Title: Stage 1/2 ROAD SAFETY AUDIT

Mixed Use Residential development at Emmet Road,

Report reference: **1621R01**

3.1 Problem

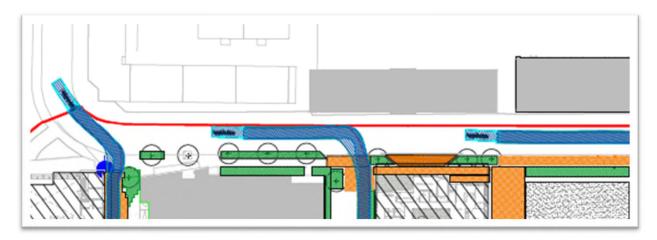
The proposed vehicular access off St. Vincent Street West is opposite the Thomas David Street West junction. The Thomas Davis Street West junction has a very large radius and turning vehicles do not have to slow to turn right into or left out of the junction. There is a risk that high turning speeds at the new crossroads could lead to collisions with vehicles or vulnerable road users.

It is recommended that the corner radius on Thomas Davis Street West be reduced.

Paragraph No. in Road Safety Audit Report	Problem accepted (yes/no)	Recommended measure accepted (yes/no)	Alternative measures (describe)	Alternative measures accepted by Auditors (Yes/No)
3.1	Yes	No	This area is outside the scope of the project. However, the D/Team will engage with DCC Roads during the detailed design phase of the scheme and assess what can be achieved in this area.	Yes
3.2	Yes	No	The design proposals include for the removal of the carparking spaces on the western side of the road for the length of the street frontage of the development. Thus, two way traffic flow can proceed unhindered in this area and pull in bays are not proposed.	Yes
